ADDENDUM 1
RFP #20-0008
PROTECTIVE CLOTHING FOR STRUCTURAL FIREFIGHTING COATS AND PANTS

The following is to ensure that vendors have complete information prior to submitting a proposal. Here are some clarifications regarding the proposal for *Protective Clothing for Structural Firefighting Coats and Pants* for *Sedgwick County Fire District #1*.

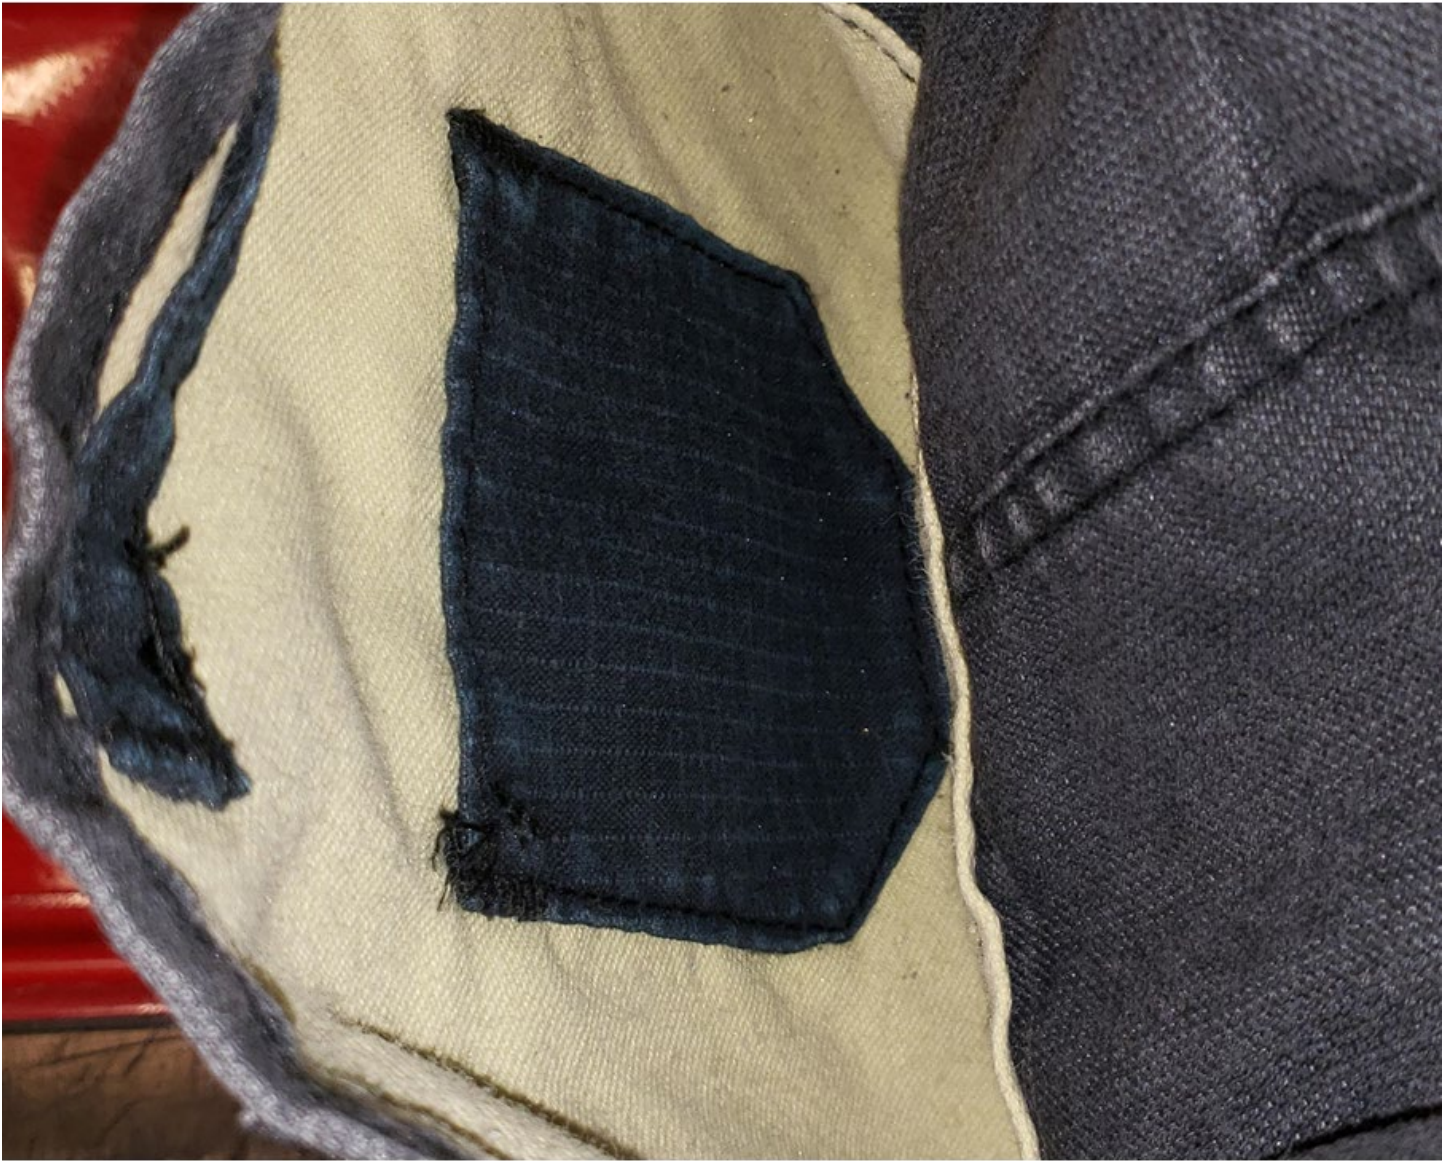
Question: Page 17, J. BCT is this a location? What does this mean?

Answer: Please see image below; 4" x 4 " patch area to reinforce material for structural integrity.
